REVISION: OVERSIGHT CONCERN - DATED FEBRUARY 23RD, 2022
SHEETS: A102, A103, A105, A200, A201, A203, A204, A300, A4.03

NO.	DESCRIPTION	DATE
1	REVISED AS PER CITY COMMENTS - DP	2021-10-27
2	OVERSIGHT COMMENTS	2022-02-23

364 E 14TH STREET
DUPLEX INFILL
COVER SHEET

4 DUPLEX INFILL - BASEMENT FLOOR AREA PLAN
1/8" = 1'-0"

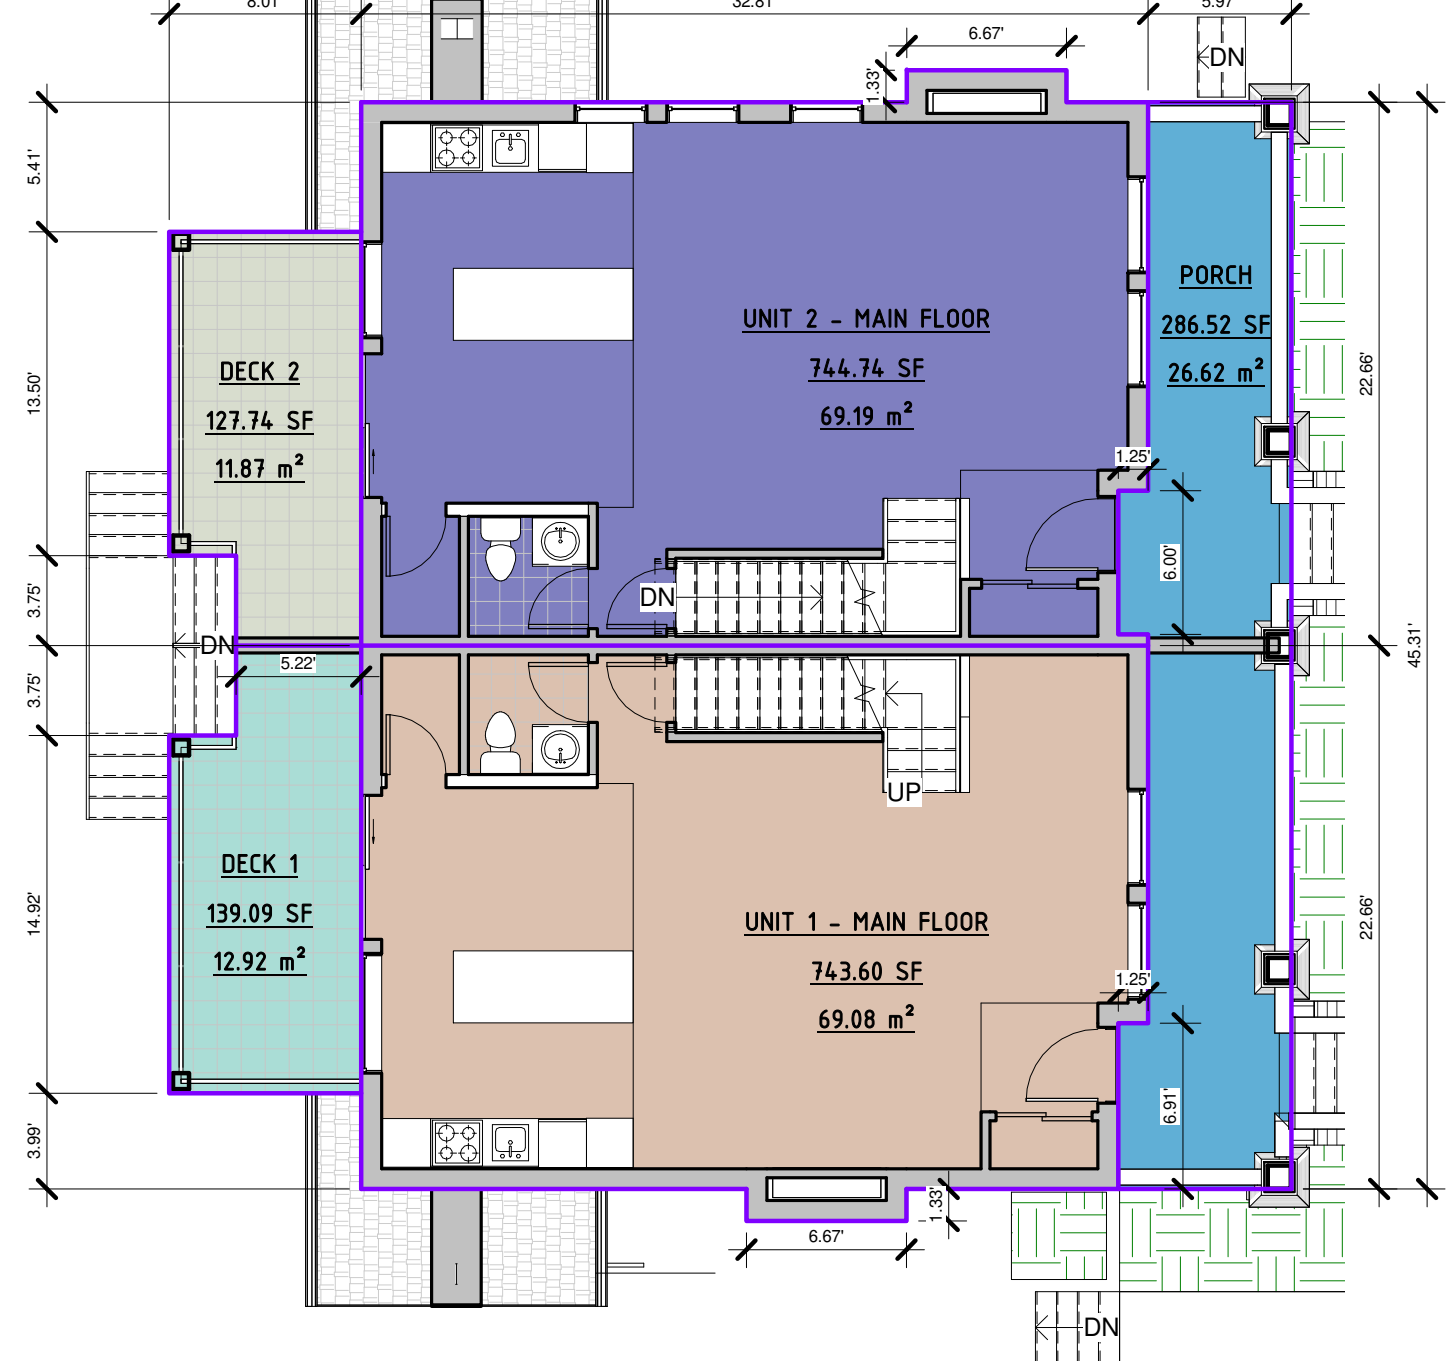
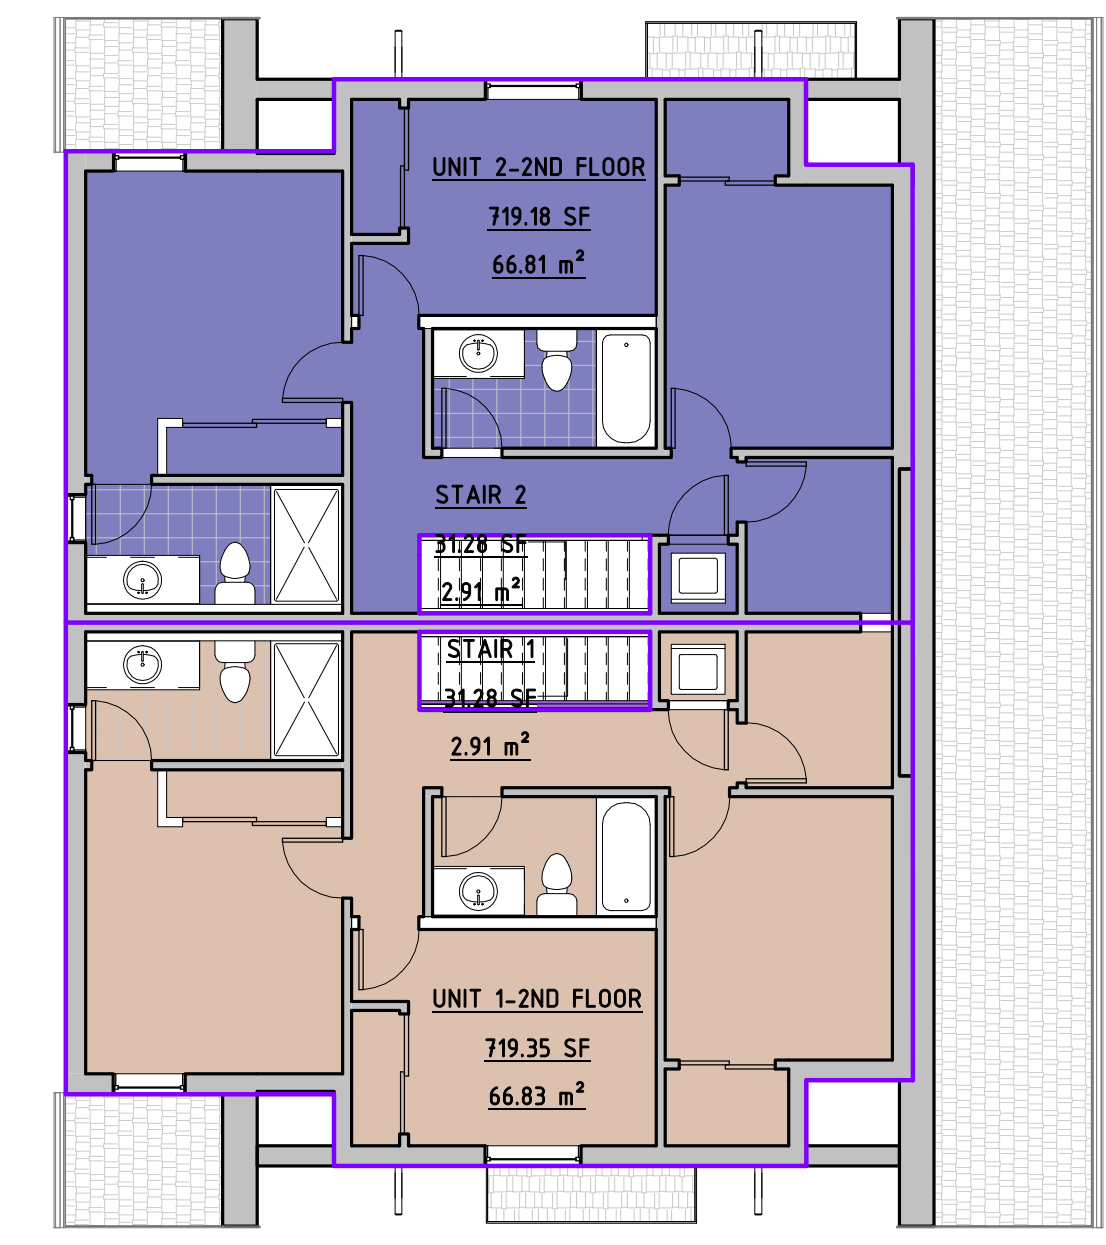
REVISIONS:
1 UPPER FLOOR AREA PLAN & CALCULATIONS UPDATED AS PER LAYOUT CHANGES

364 E 14TH STREET
DUPLEX INFILL
INFILL - N & S ELEVATIONS

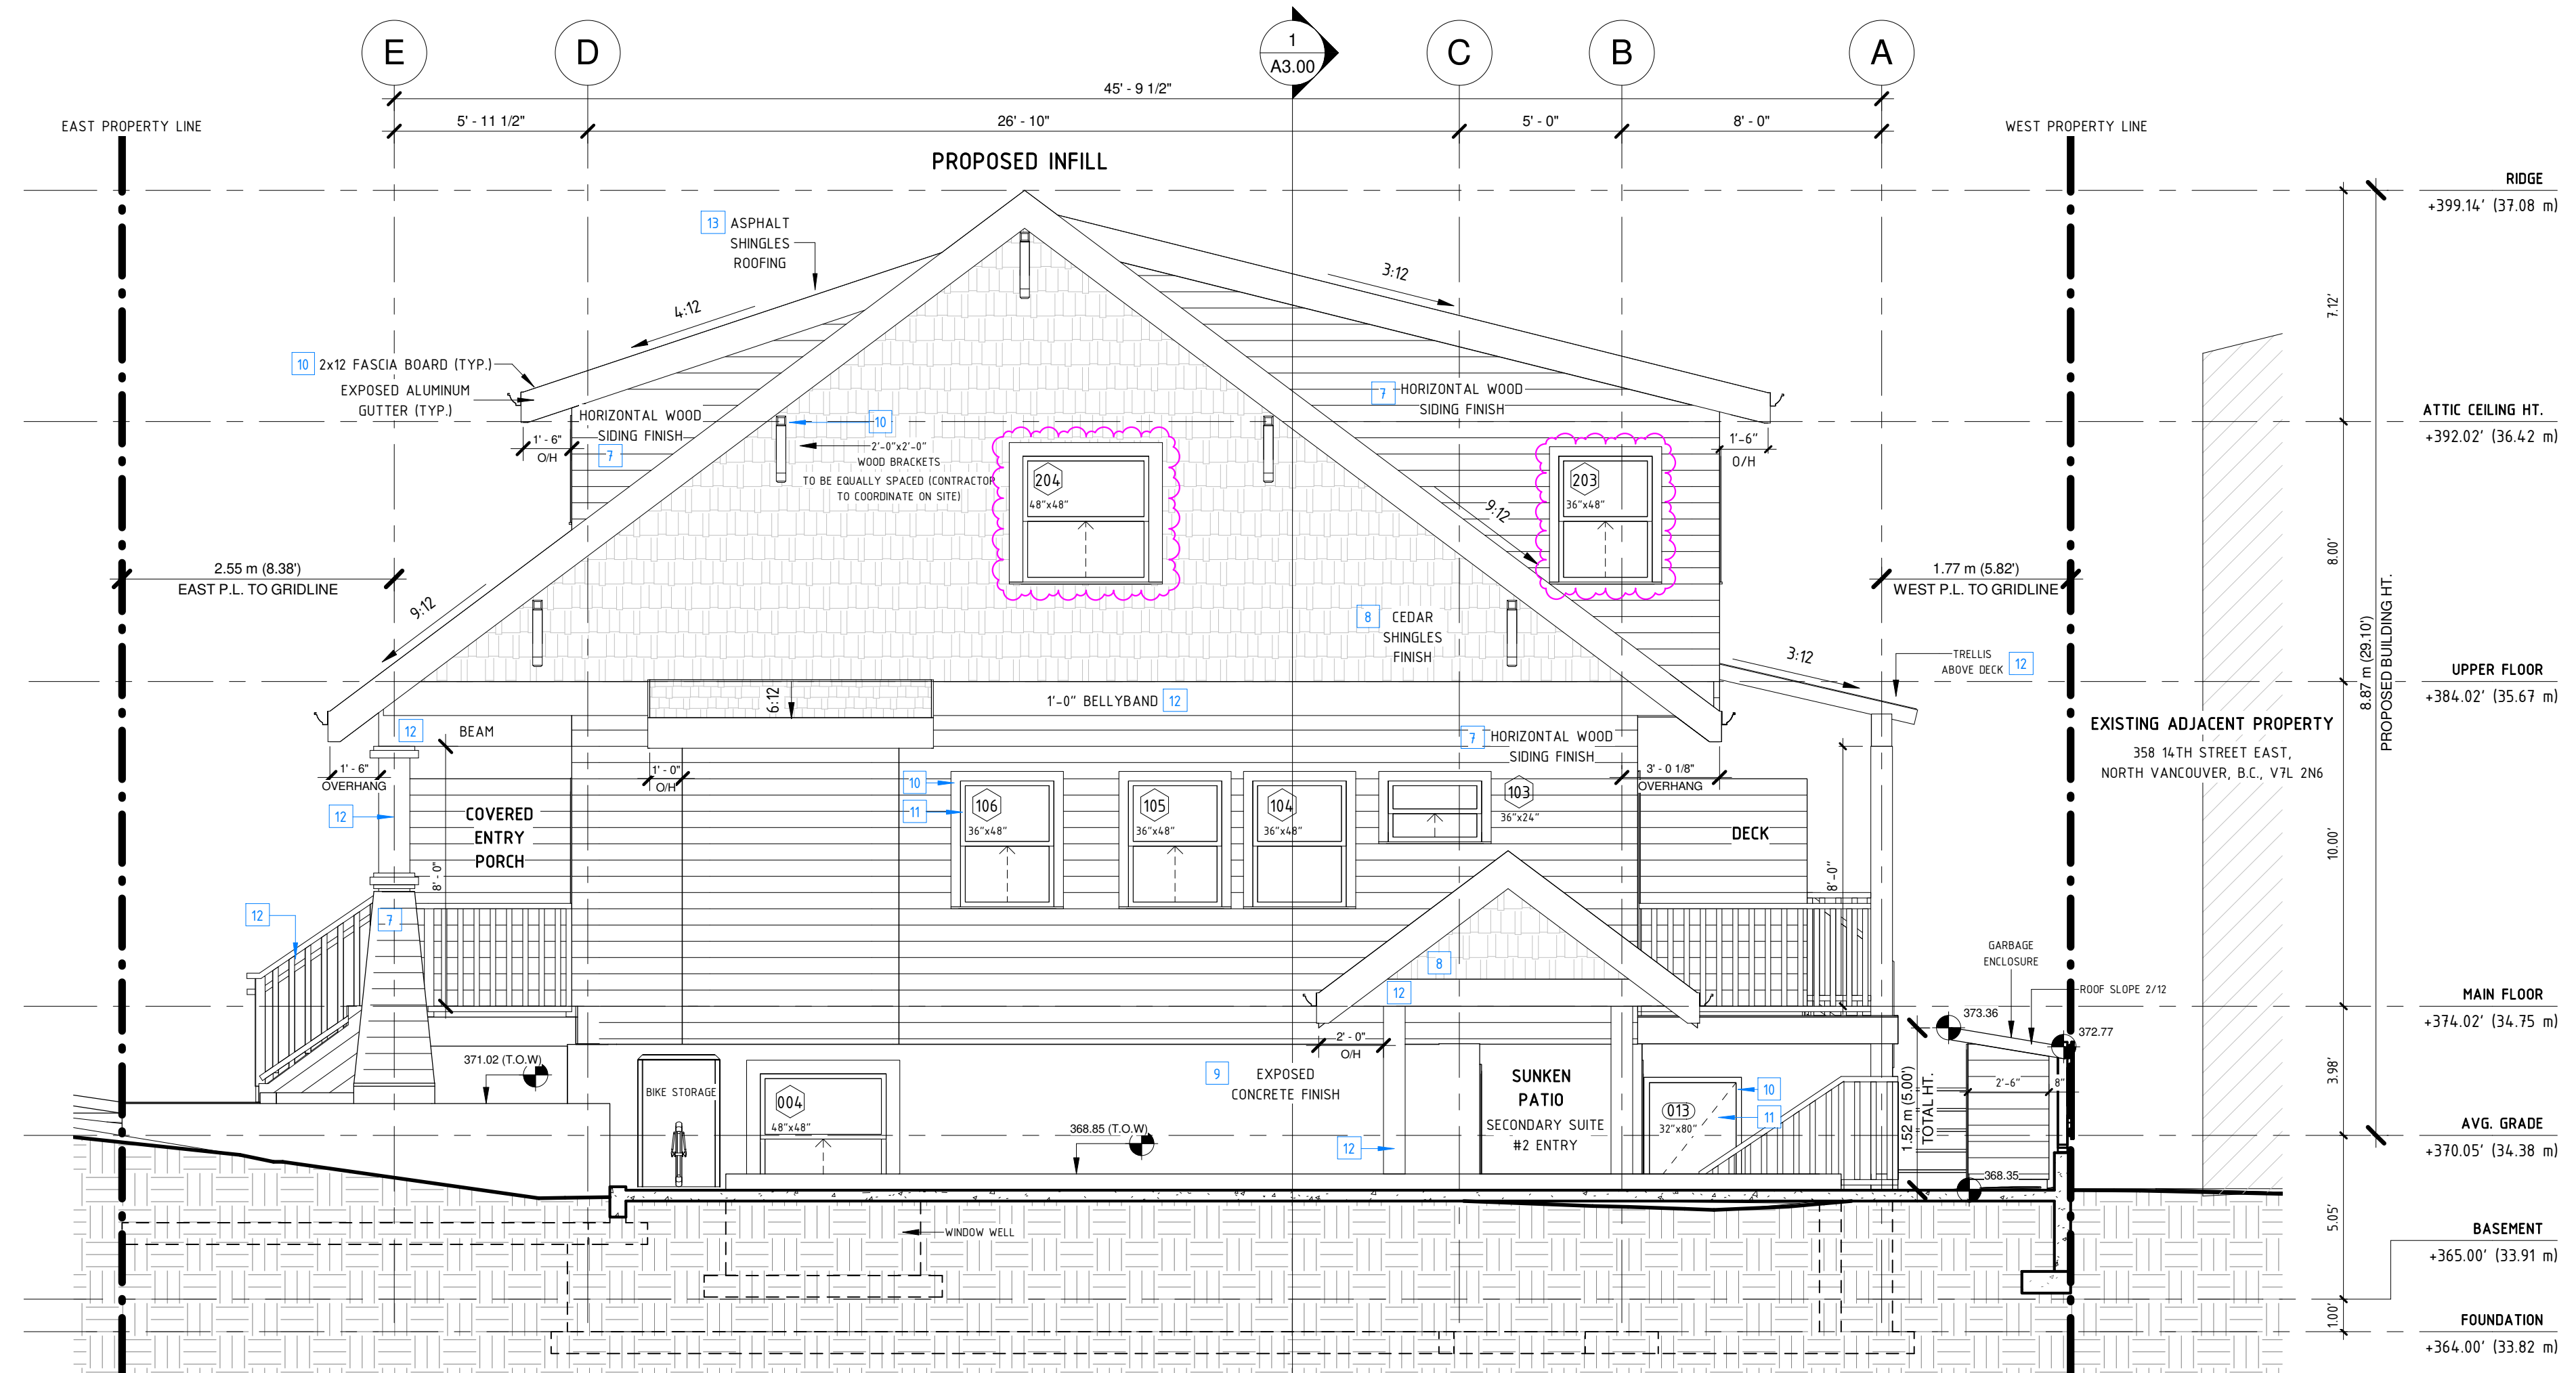
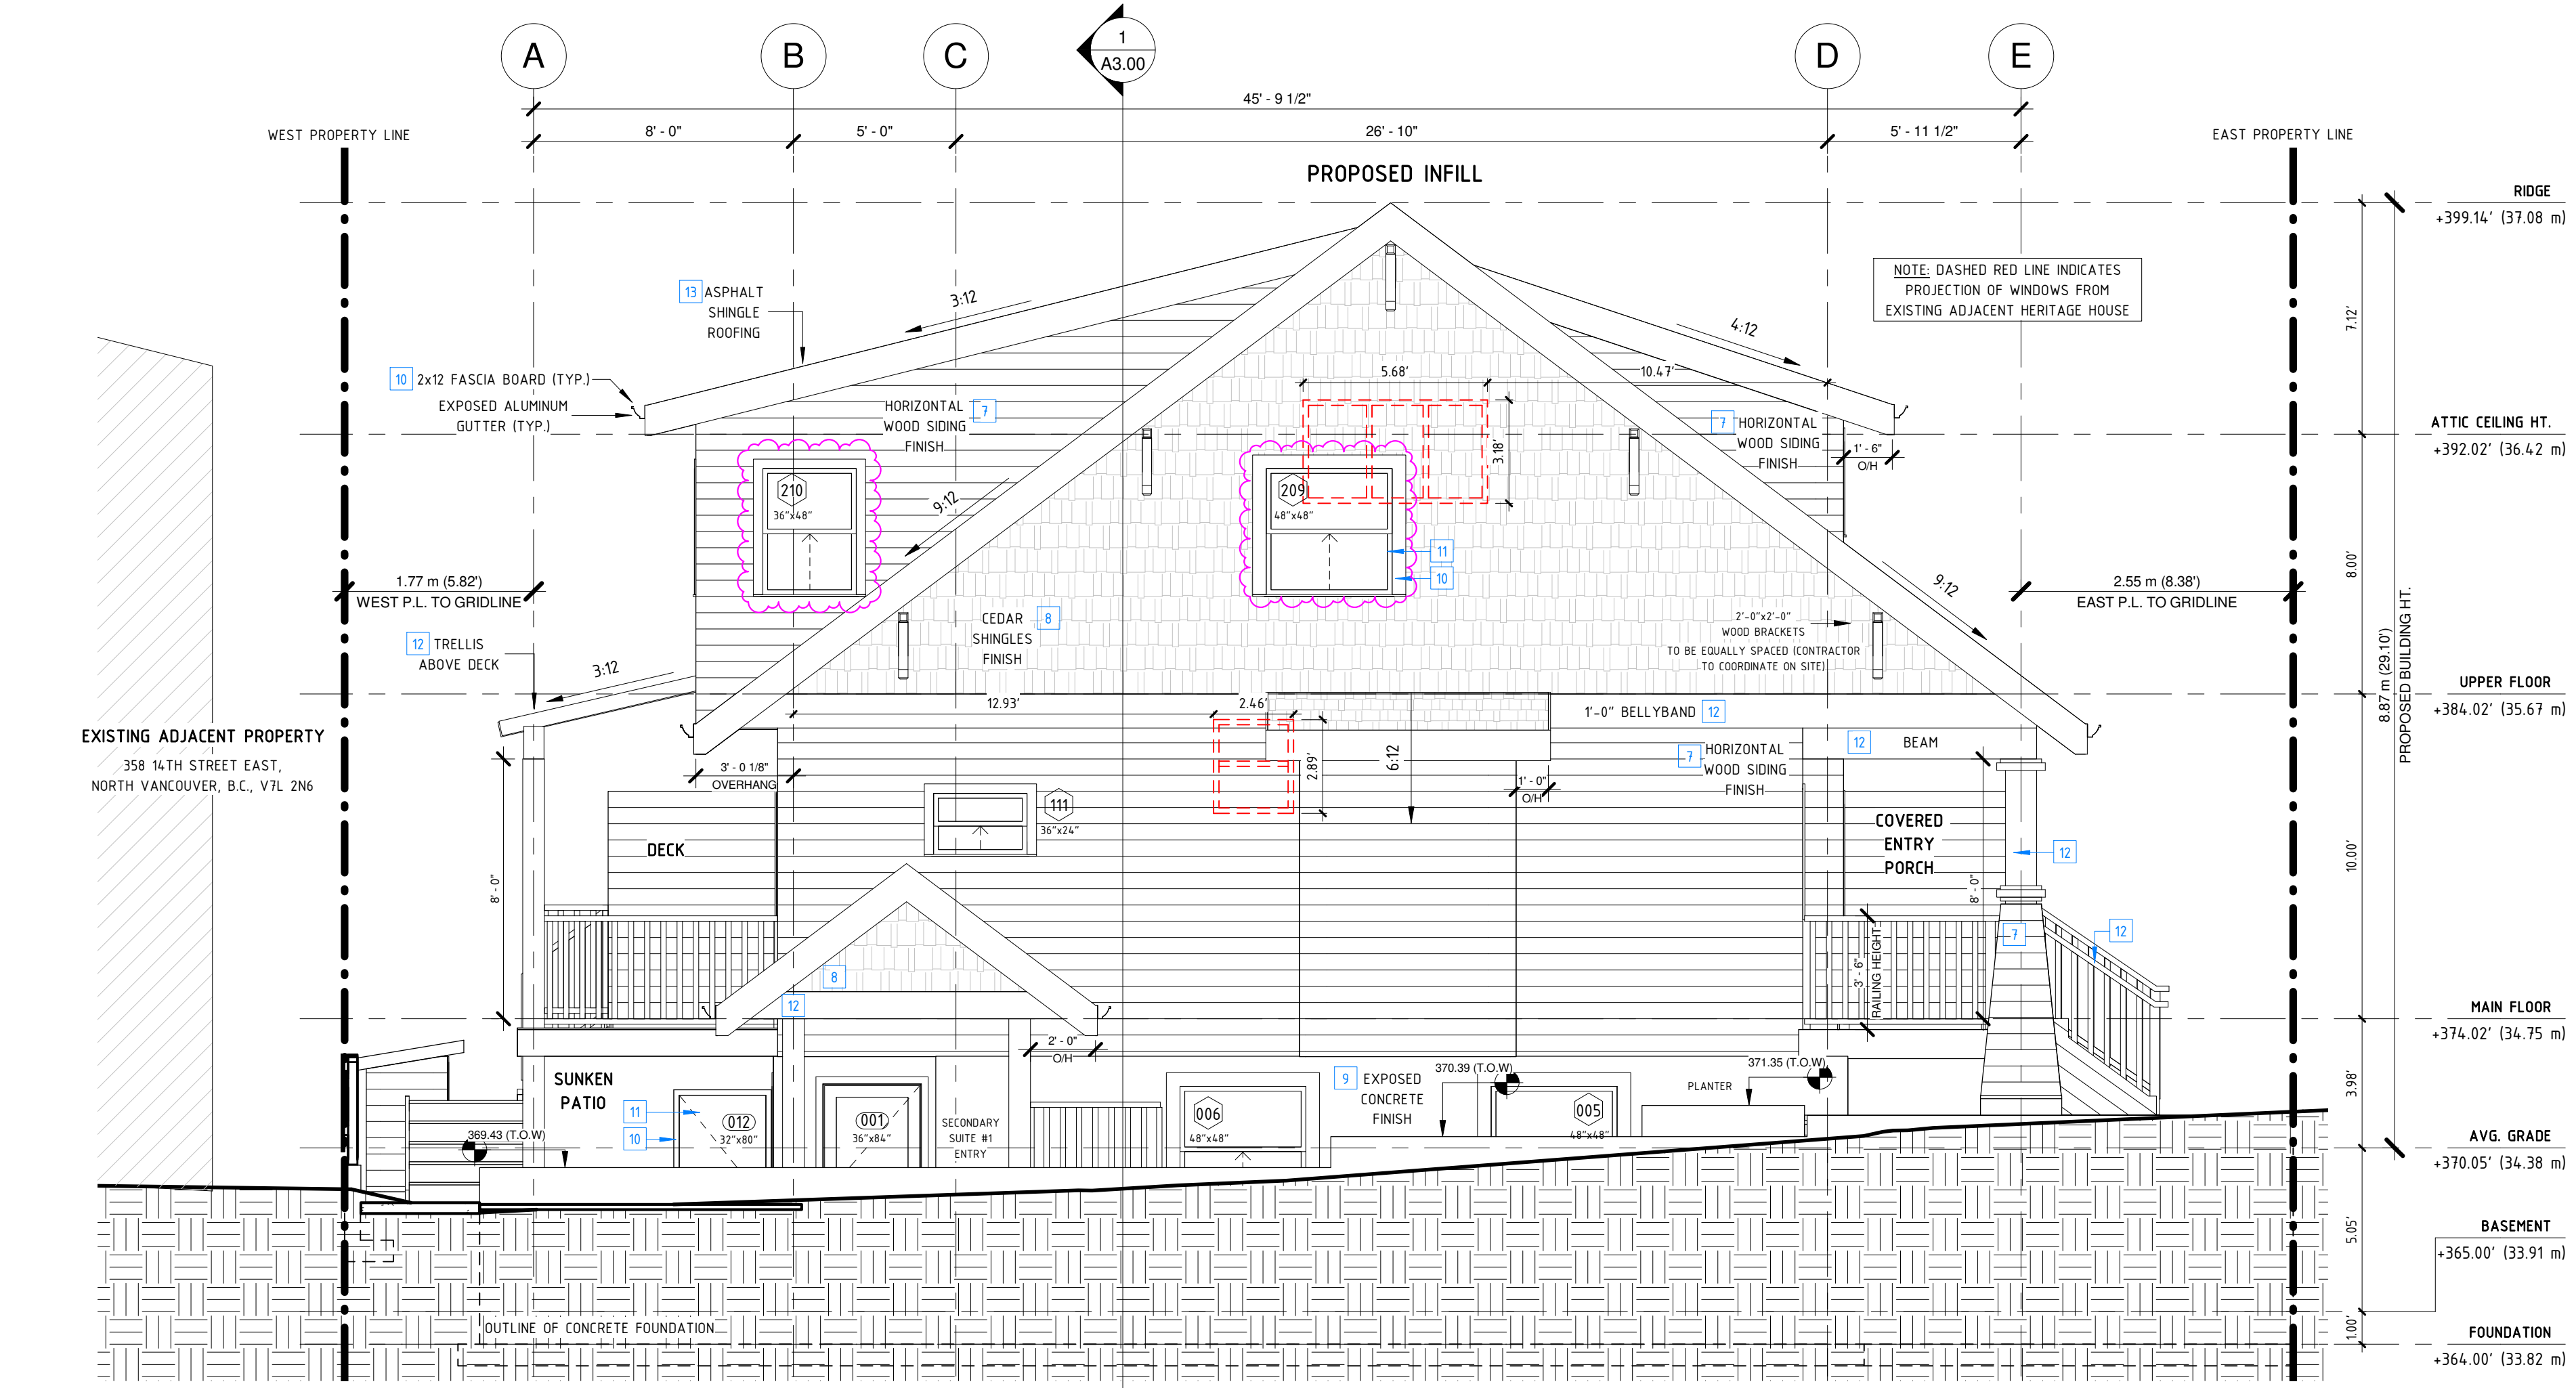
REVISION:
1) REDESIGN OF THE UPPER FLOOR TO PUT THE BEDROOM WINDOWS FACING NORTH AND SOUTH INSTEAD OF WEST
2) BATHROOM WINDOWS FACING WEST TO BE Frosted GLASS
